SUBJECT: PLANS AND PROPOSAL ADDENDUMS
PROJECT: STP 2023 (675)MM CONTROL: 1433-02-044
COUNTY: COMAL
LETTING: 05/04/2023
REFERENCE NO: 0419

PROPOSAL ADDENDUMS

DESCRIPTION OF ABOVE CHANGES
(INCLUDING PLANS SHEET CHANGES)

677-6003	ELIM EXT PAV MRK & MRKS (8")	LF	0
677-6007	ELIM EXT PAV MRK & MRKS (24")	LF	0
677-6008	ELIM EXT PAV MRK & MRKS (ARROW)	EA	0
677-6012	ELIM EXT PAV MRK & MRKS (WORD)	EA	0
677-6020	ELIM EXT PAV MRK & MRKS (MED NOSE)	EA	0

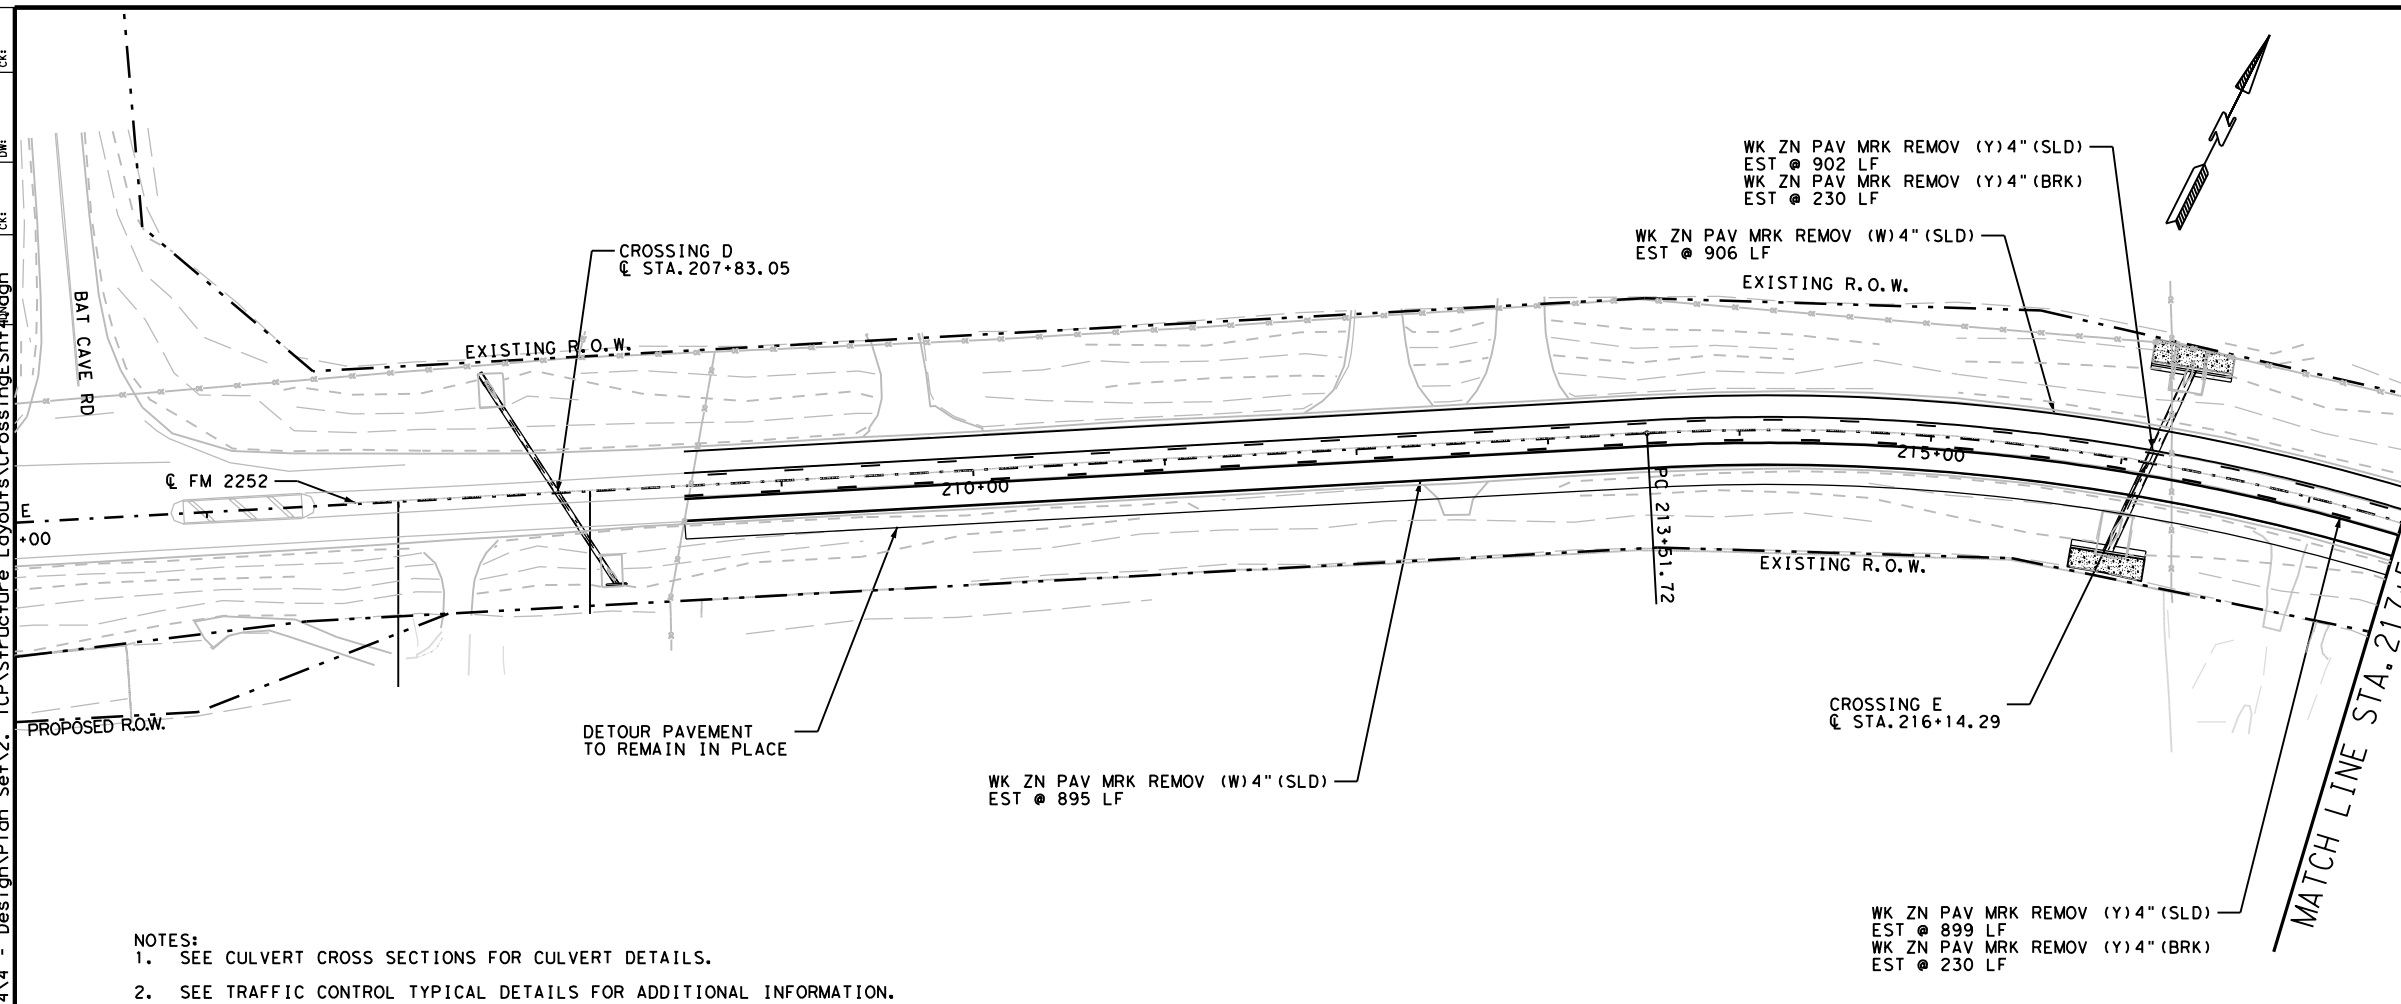
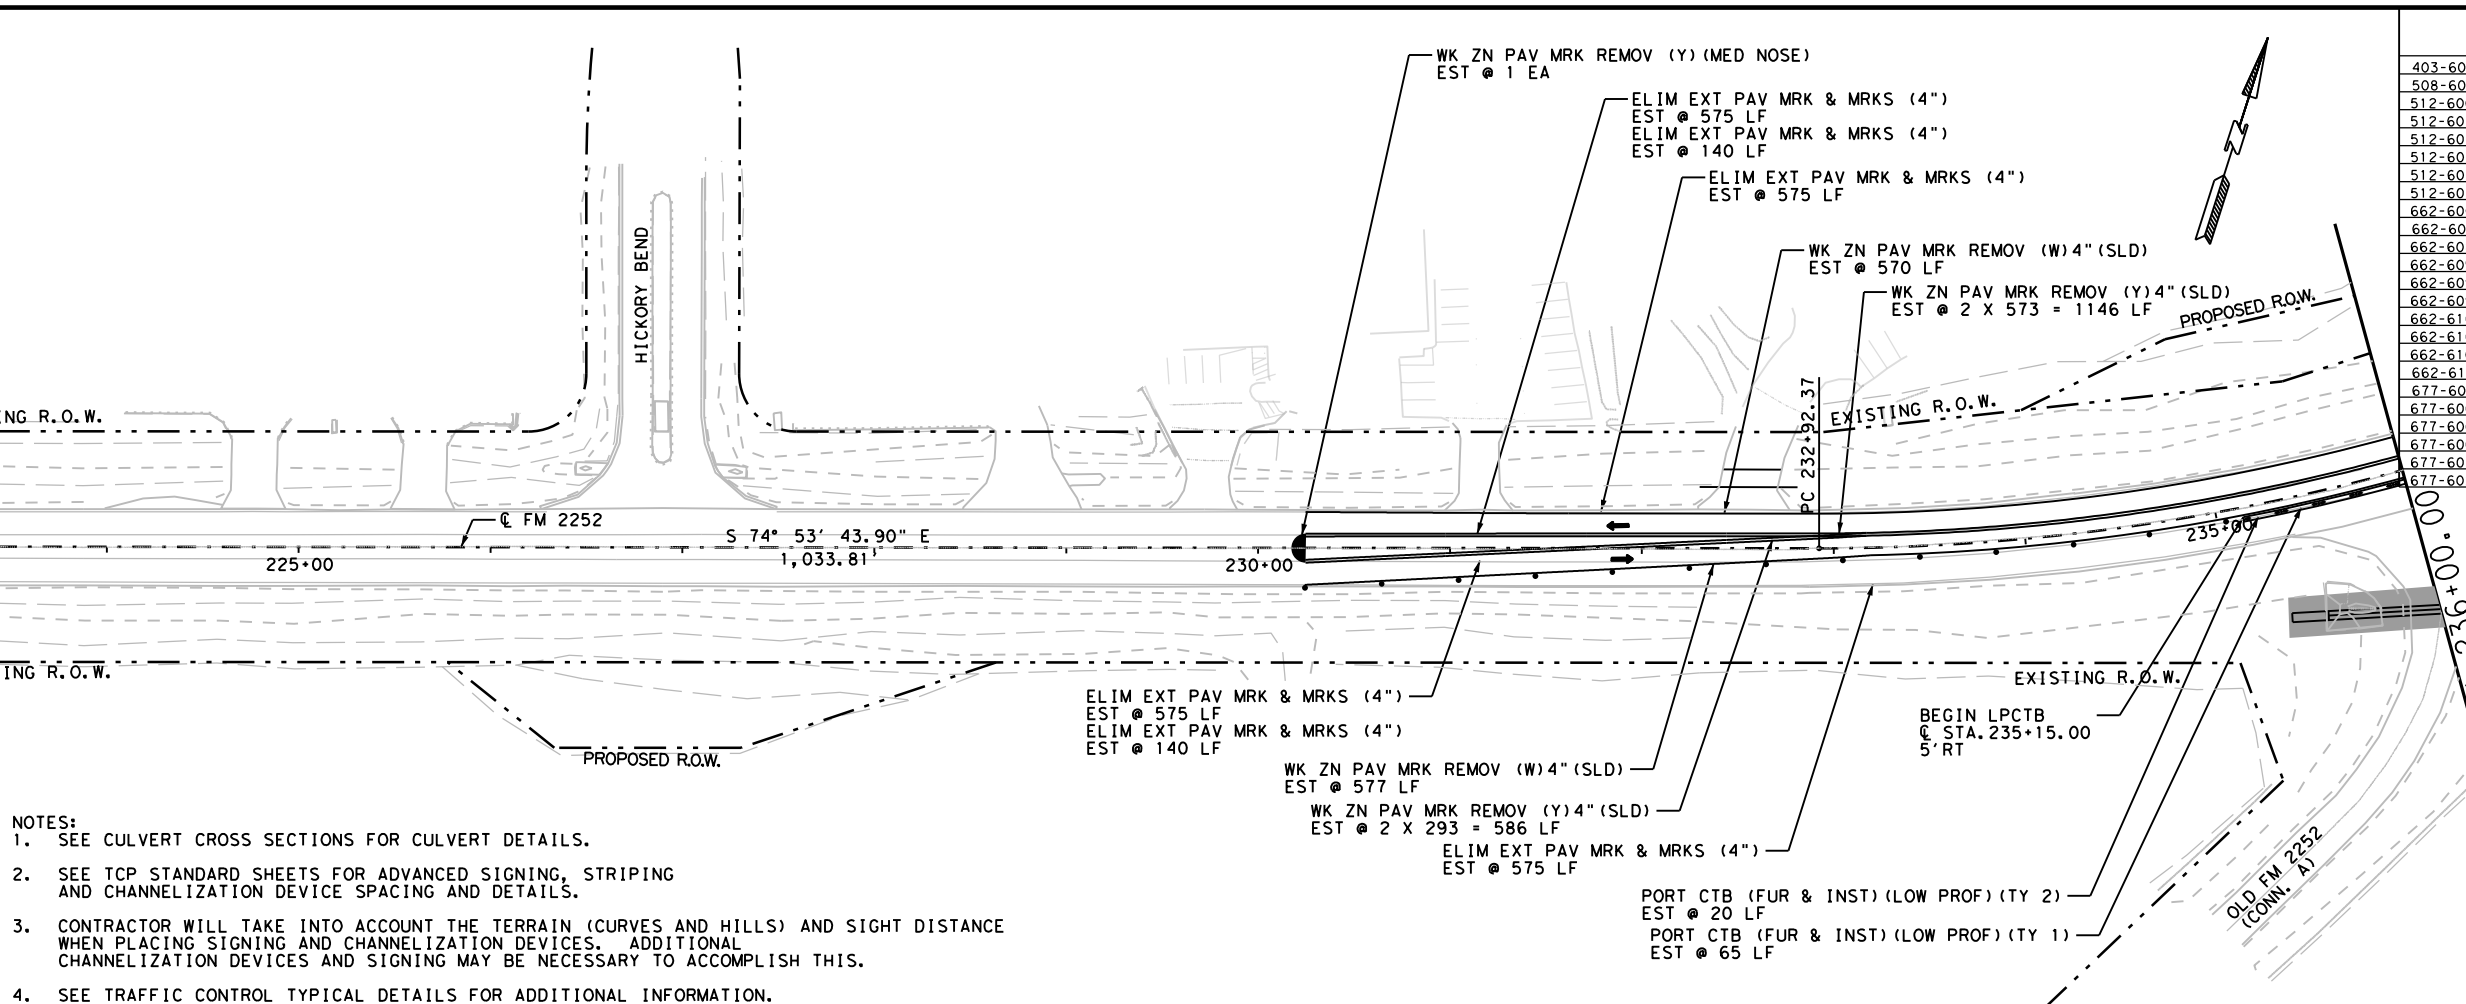
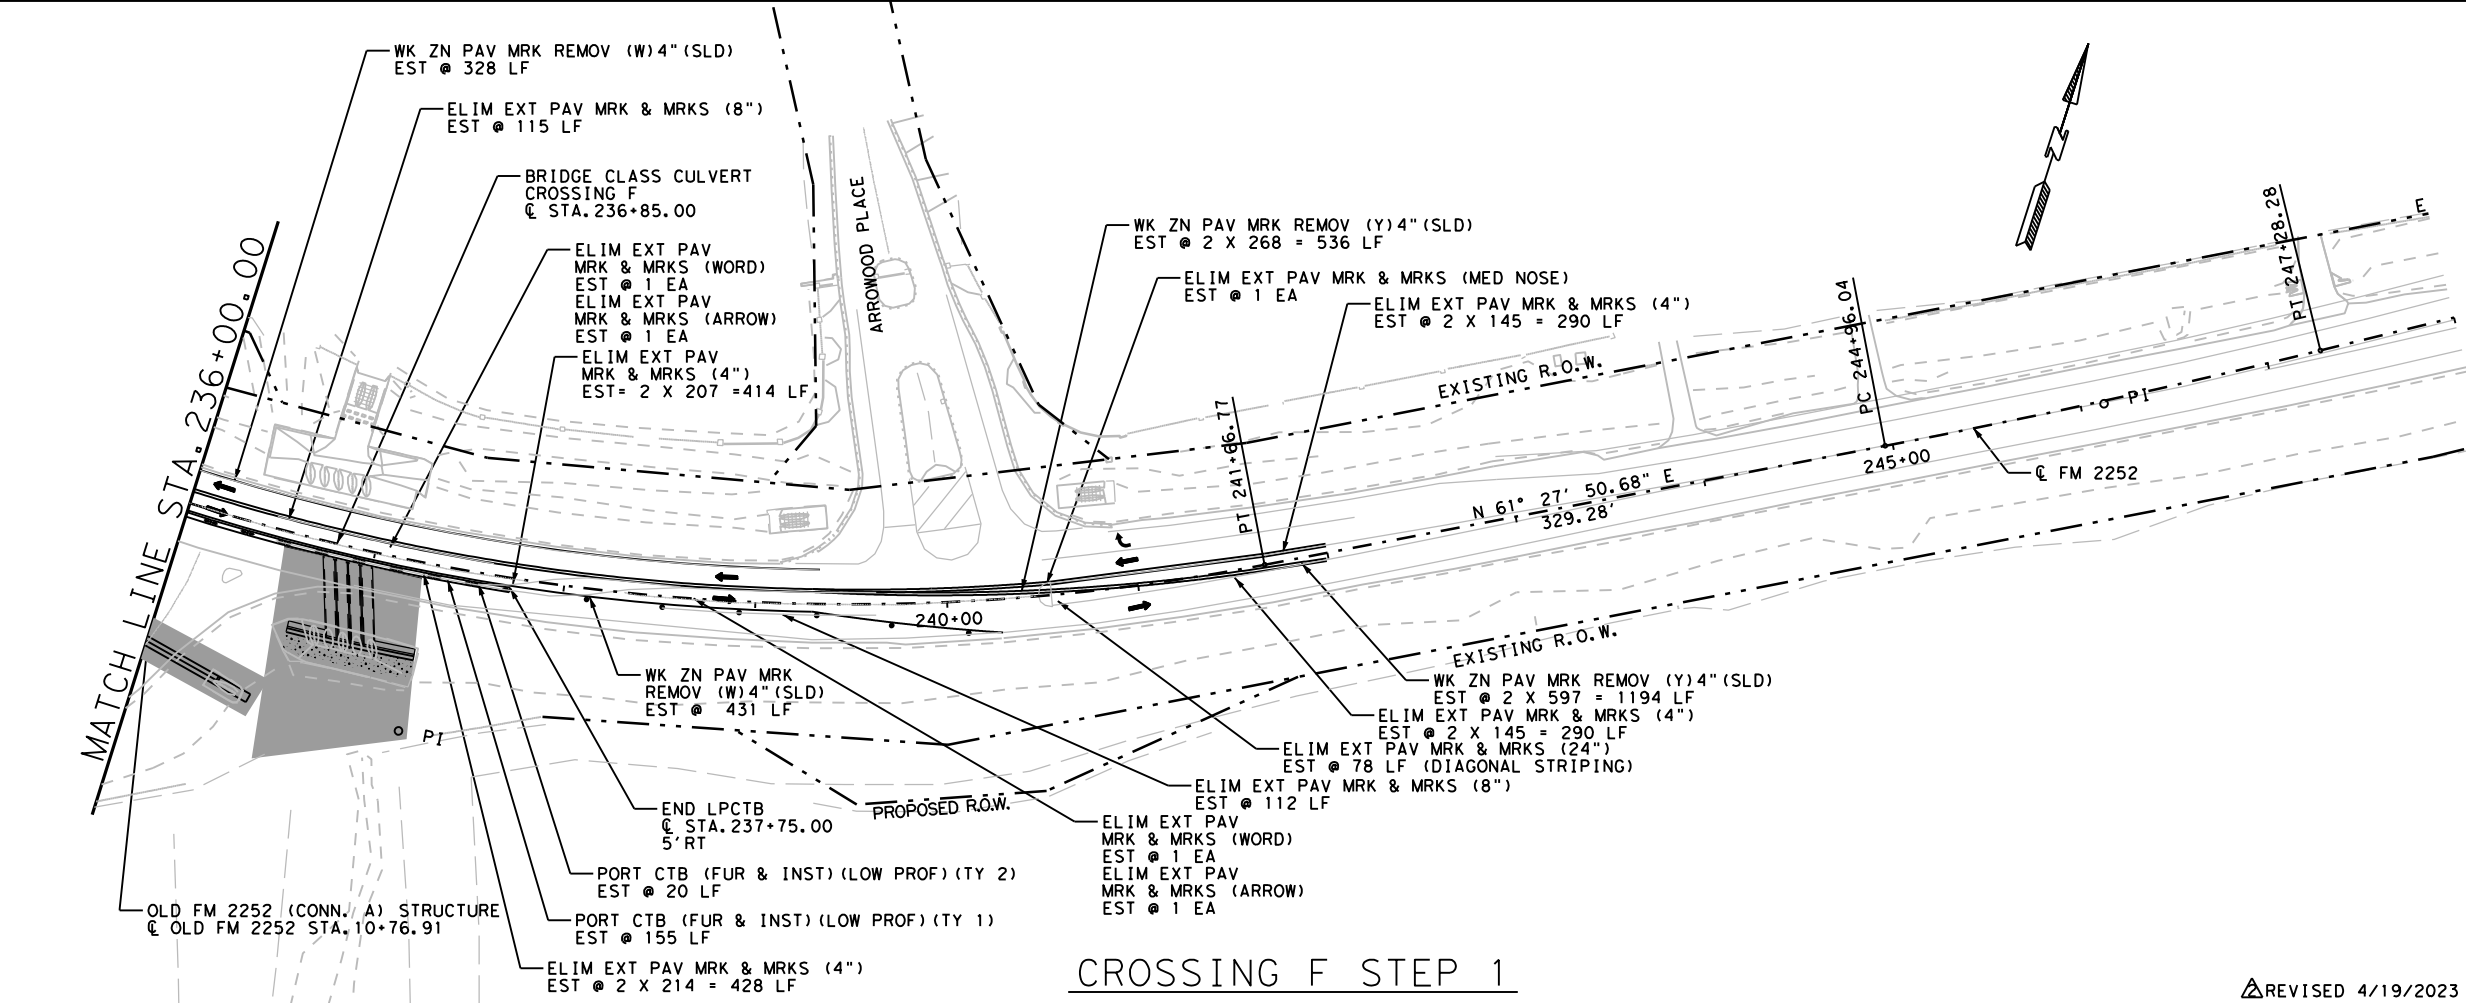
SHEETS 275-278, 280-283, 285-288 AND 290-293: ADDED ITEM NO. 403-6001
